## **Victorian Reactive Power Support Project**

### **RIT-T PADR**

The Major Energy Users is pleased to respond to the AEMO Project Assessment Draft Report (PADR) of its proposed Victorian Reactive Power Support Project.

**Figure 14 Option 1B gross benefits and investment costs**

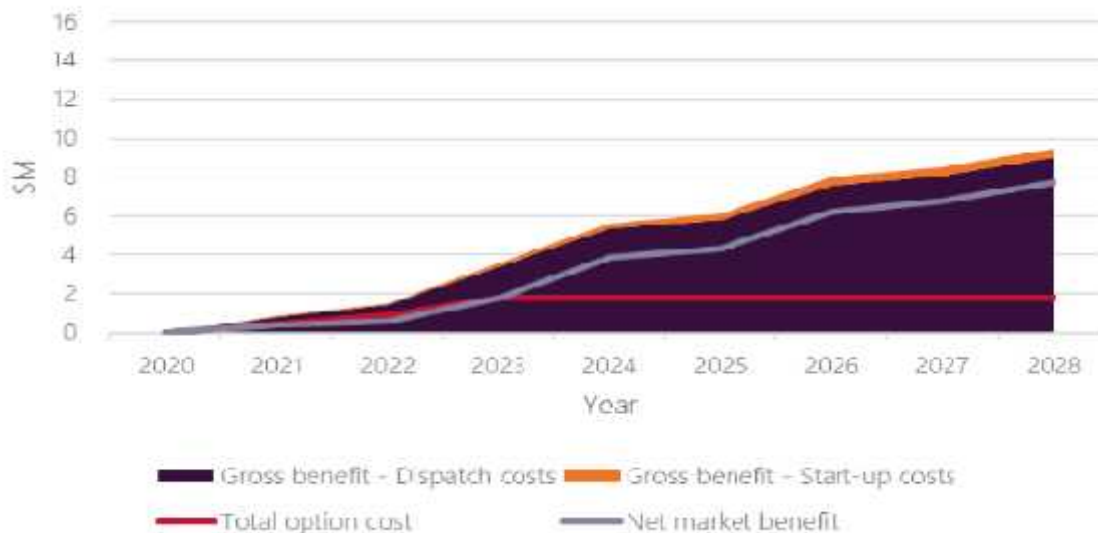
additional benefit to Victorian consumers, in that the benefits generated by option 2 over the option 1B are essentially from lower dispatch costs in NSW (and Queensland) and export to NSW. The value of this benefit is shown by the differences between figures 14 and 17 in the PADR.

**Figure 17 Option 2 gross benefits and investment costs**

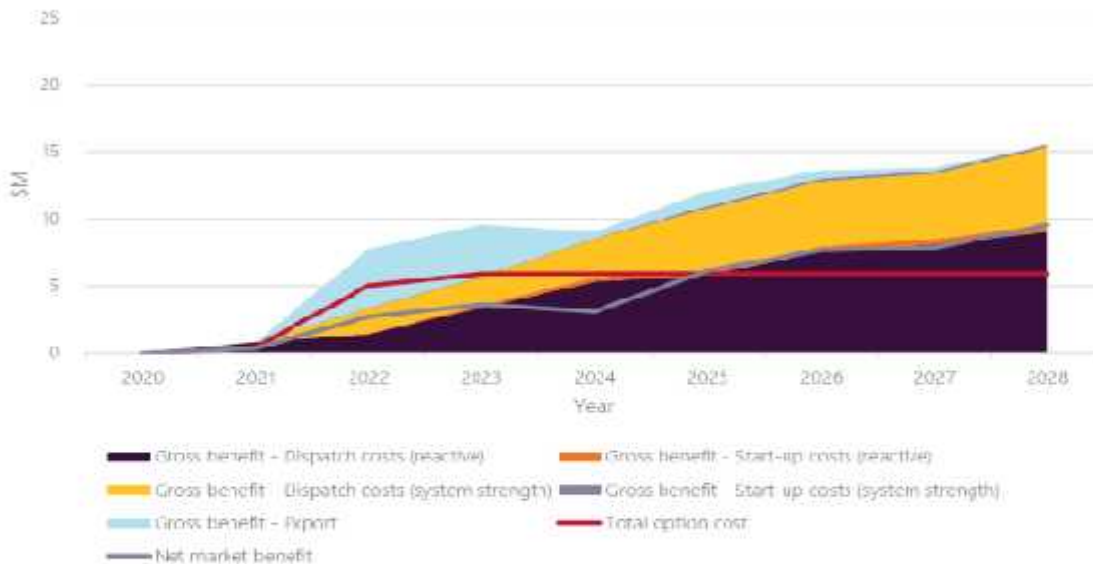
The Option 2 gross market benefits include the additional benefits from increasing the Victoria to New South Wales export limit. These benefits are highest in 2022 and 2023 and decrease from 2024 onwards as additional investment in the transmission network (see Section 5.2.7) increase the export limit in the 'do nothing' base case.
